ATTACHMENT F: Proposed change to Cardrona Development Contribution Contributing Area Maps – page 27 of 40, see supporting documents to in the Development Contribution Policy 2021; Volume 2 of 2021/31 Ten Year Plan

The below figure in the QLDC TEN YEAR PLAN 2021–2031 VOLUME TWO Development Contribution Policy 2021 – Supporting Documents; Contributing Area Maps Page 27 of 40 Cardrona 17.1 - Water Supply & Wastewater shall be amended as shown below.

17. Cardrona
17.1 Water Supply & Wastewater

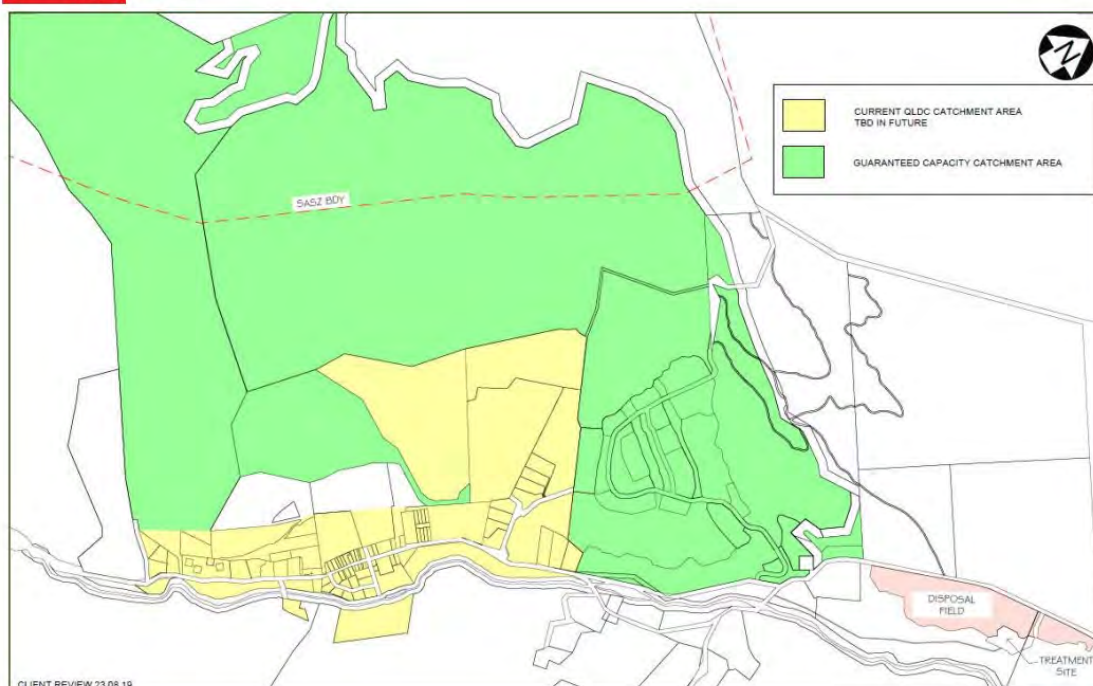
Specifically first such that the title and reference of *17.1 Water Supply & Wastewater* to be amended in title and reinstated as *17.1 Wastewater*. Removing any reference to water supply.

Second, a new map 17.2 Cardrona Water Supply to be adopted as per Attachment E, and as shown below.
